Well Name: KITE 5 I FED	Well Location: T18S / R27E / SEC 5 / NESE /	County or Parish/State: EDDY / NM
Well Number: 2	Type of Well: OIL WELL	Allottee or Tribe Name:
Lease Number: NMLC055383A	Unit or CA Name:	Unit or CA Number:
US Well Number: 300152906700C1	Well Status: Producing Oil Well	Operator: REDWOOD OPERATING LLC

Notice of Intent

Type of Action: Plug and Abandonment

Plug Abandonment NOI Proposed

Redwood		PROPOSED	
Author:	Abby @ BCM	Well No.	#2
Well Name	Kite 5 I Federal	API #:	30-015-29067
Field/Pool	Redlake;Qn-GB-	Location:	Sec 5, T18S, R27E
County	SA-GL-Yeso		2310' FSL & 890' FEL
State	Eddy		
Spud Date	New Mexico	GL:	3508
	5/23/2000

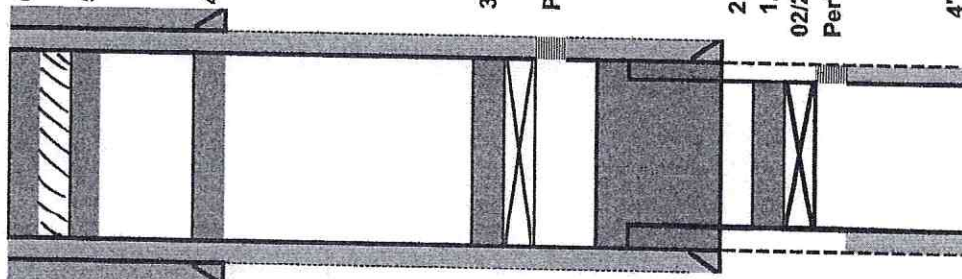
1. Tag 4" CIBP @ 2790' w/ 35' cmt on top. ~~Tag TGC & spot 10 sx to 2629'~~
2. Perf & Sqz 30 sx cmt @ 2400-~~2188'~~ 2165'. WOC & Tag (5 1/2" Shoe & top of 4" Liner)
3. Set 5 1/2" CIBP @ 1585'. Circ hole w/ MLF. Pressure test csg. Spot ~~25~~ 30 sx cmt @ 1585-~~1385'~~ 1362'. (San Andres)
4. Spot 25 sx cmt @ 1131-931'. WOC & Tag (8 5/8" Shoe & Grayburg)
5. ~~Spot 30 sx cmt @ 732-450'~~ (Queen & Bowers)
6. Spot ~~25~~ 50 sx cmt @ ~~200'~~ 450' to surface.
7. Cut off well head, verify cmt @ surface, weld on Dry Hole Marker.

Plug Type	Top	Bottom	Length	Tag	Sacks	Notes
Surface Plug	0.00	400.00	400.00	Tag/Verify		
				If solid base no need to Tag (CIBP present and/or Mechanical Integrity Test), If Perf & Sqz then Tag, Leak Test all CIBP if no Open Perforations		
Yates @ 150	98.50	200.00	101.50			
				If solid base no need to Tag (CIBP present and/or Mechanical Integrity Test), If Perf & Sqz then Tag, Leak Test all CIBP if no Open Perforations		
Fresh Water @ 350	296.50	400.00	103.50		50.00	Spot from 450' to surface. Verify at surface.
Shoe Plug	1020.19	1131.00	110.81	Tag/Verify	25.00	Spot from 1131' to 931'. WOC and Tag.

If solid base no need to Tag (CIBP present and/or Mechanical Integrity Test), If Perf & Sqz then Tag, Leak Test all CIBP if no Open Perforations		
San Andres @ 1366	1302.34	1416.00	113.66	ns		
				If solid base no need to Tag (CIBP present and/or Mechanical Integrity Test), If Perf & Sqz then Tag, Leak Test all CIBP if no Open Perforations		
CIBP Plug	1550.00	1585.00	35.00	ns	30.00	Leak Test CIBP. Spot from 1585' to 1302'.
Perforations Plug (If No CIBP)	1585.00	2111.00	526.00	Tag/Verify

If solid base no need to Tag (CIBP present and/or Mechanical Integrity Test), If Perf & Sqz then Tag, Leak Test all CIBP if no Open Perforations		
Liner Top @ 2238	2165.62	2288.00	122.38			
Shoe Plug	2275.51	2399.00	123.49	Tag/Verify	30.00	Perf and Squeeze from 2400' to 2165'. WOC and Tag.
				If solid base no need to Tag (CIBP present and/or Mechanical Integrity Test), If Perf & Sqz then Tag, Leak Test all CIBP if no Open Perforations		
Glorieta @ 2707	2629.93	2757.00	127.07		10.00	Tag TOC and spot to 2629'.
Perforations Plug (If No CIBP)	2791.00	3158.00	367.00	Tag/Verify		Not Necessary
Shoe Plug	3472.42	3608.00	135.58	Tag/Verify		Not Necessary
